SEWAGE DISPOSAL SYSTEM

MARYLAND STATE DEPARTMENT OF HEALTH

P 40253

A REPAIR

P 40253

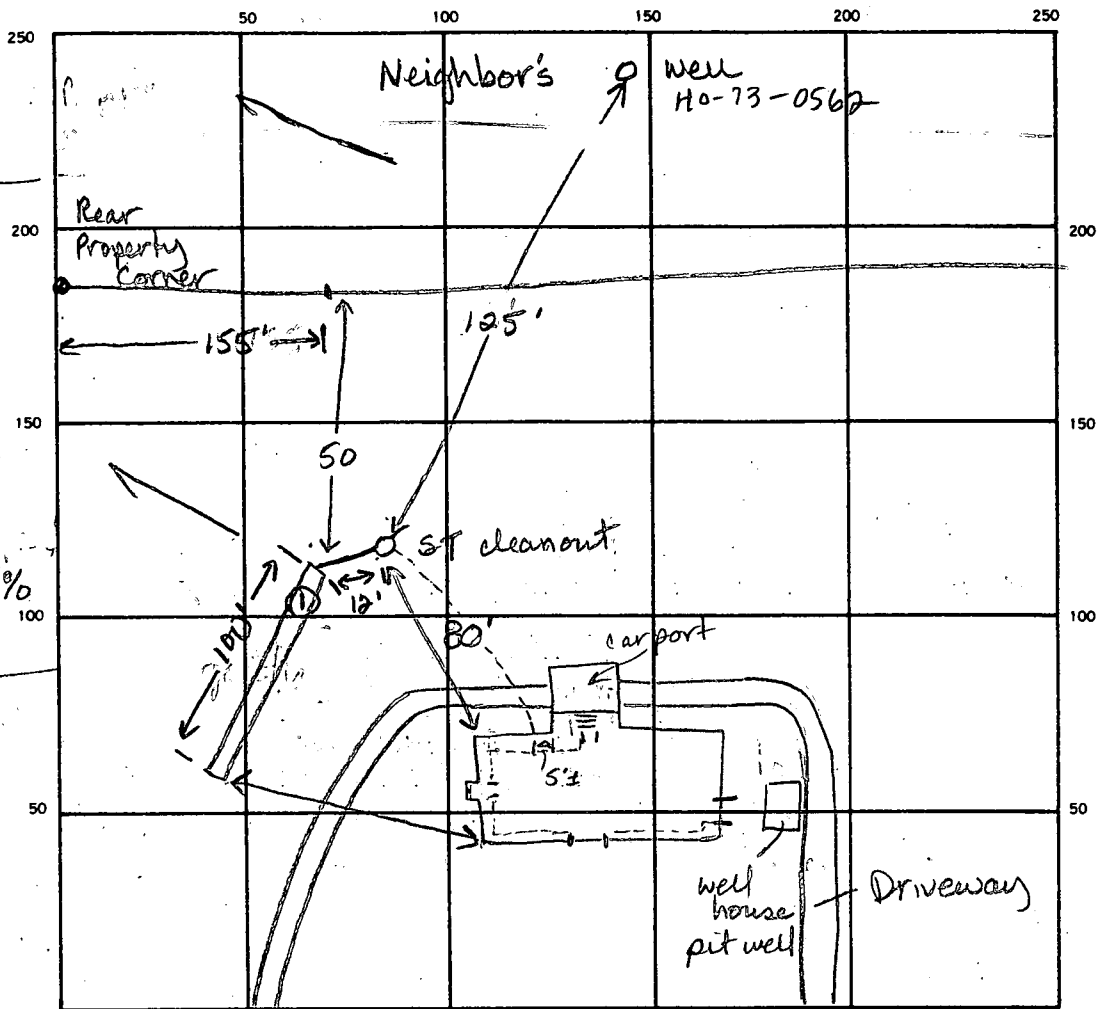
10-16-87 140 sq ft per bedroom. start inlet at 5 feet. Bottom of trench at 10.5 feet. Effective depth starts at 5 feet, 11 feet of stone.

Start the trench 155 ft. from the rear left property corner (Rt 97) and 50 feet from rear property line as seen when facing property from Old Frederick Road. Extend trench toward Old Frederick Rd. JEN

REMARKS 10-15-87 No one on site. Rescheduled for tomorrow at 10am. 10-16-87
Estimated septic tank capacity - 2000 gal +. Perc test, at 40 ft slow, at 5.5'
Prewet: 10:59^{am} to 11:02, 11:02 to 11:05^{am} = 3 minutes. JEN. 10-16-87 OK to add stone
pipe and paper to trench. Several sections of decomposed rock 5' long.
Can cover center leaving ends open. JEN. 10-16-87 OK to cover all
work JEN.
